## LANDSCAPE REVIEW BOARD MEMORANDUM

**SUBJECT:** LRB22-0003 Public hearing and consideration of a request from Baird, Hampton & Brown for a variance to Chapter 114 (Vegetation) of the North Richland Hills Code of Ordinances at 4525 City Point Drive, being 1.65 acres described as Lots 6R and 7, Block 1, North Edgely Addition.

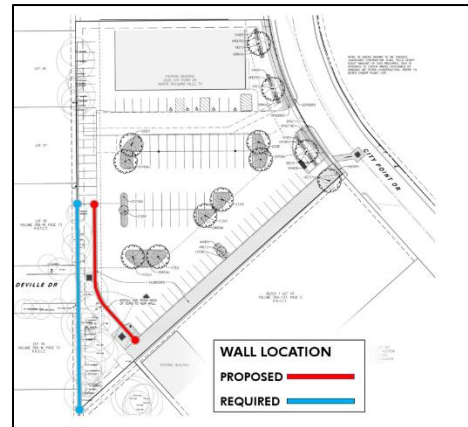
The applicant is requesting a variance to allow the screening wall to be constructed at a location other than on the common property line. The wall would be constructed to follow the western edge of the parking lot, which is curved along the southwest portion of the lot. The distance between the common property line and the wall ranges from approximately 18 feet to 55 feet. The location of the wall would screen the parking lot from adjacent properties; however, it would not provide complete screening of the commercial property. The exhibit (right) shows the required and proposed location of the screening wall.

If the screening wall is constructed as proposed, the buffer yard would be located between the wall and the residential properties. The existing residential fences would remain in place. The DRC noted concerns that maintenance of the area between the two fences could become problematic as the area would not be readily noticeable from the site or adjacent properties. Additionally, the lack of visibility of the space could result in an attractive area for undesirable activities. The DRC recommends that the screening wall be constructed on the common property line as required by the code standards.

Deny LRB22-0002.
